WASHINGTON METROPOLITAN AREA TRANSIT AUTHORITY
PUBLIC HEARING STAFF REPORT
PROPOSED CONSTRUCTION OF SILVER SPRING TRANSIT CENTER
RED LINE
MONTGOMERY COUNTY, MARYLAND
HEARING NO. 173
DOCKET NO. R-06-3

**FINAL PUBLIC HEARING
STAFF REPORT**

**PROPOSED CONSTRUCTION OF
SILVER SPRING TRANSIT CENTER
MONTGOMERY COUNTY, MARYLAND**

HEARING NO. 173
DOCKET NO. R06-3

D. Bicycle Parking and Storage

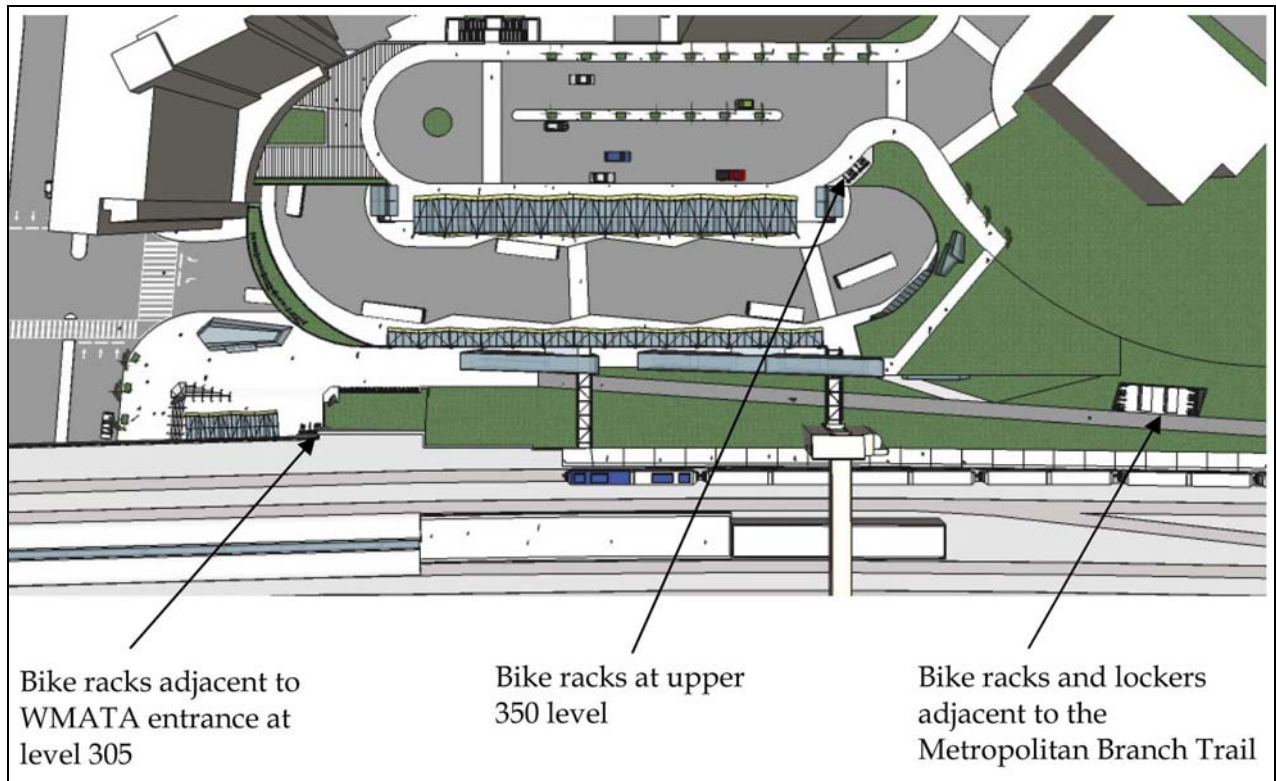
Mr. Gray	The transit center should include secure and sufficient bicycle parking.
Mr. Gilliland	More bicycle racks and lockers are needed. Racks should be sheltered and located in high-traffic areas. Lockers are needed at the north end of the station.
Mr. Reis (testimony)	The proposed number of racks and lockers is inadequate.
(correspondence)	The proposed bicycle parking and storage locations are unmonitored and unprotected from the elements. More lockers are needed at the north end of the station.
Mr Tibbits (testimony & correspondence)	Locating bicycle racks at the perimeters leaves them unprotected from theft.
Mr. Unger	The plan lacks bicycle lockers near the Metrorail station entrance. Lockers should be located on the north and south sides of the station. Bicycle racks do not provide sufficient security.
Mr. Smith	There are not enough bicycle racks.

Ms. Spielberg Additional bicycle lockers should be included and should be close to the Metrorail station entrances.

Ms. Siegel The plan should include more bicycle racks and lockers, and they should be better located.

In locating bicycle parking and storage facilities, a balance has to be reached between maximizing the proximity to the Metrorail station entrance and impeding pedestrian access. The project architects are examining locations for additional racks and lockers on the southeast and southwest sides of the station. The objective is to define bicycle storage areas that will be as close as possible to the station entrance and sufficiently close to well-traveled areas in order to provide security, yet not directly in pedestrian paths. Some of the areas under consideration are shown in the drawing below.
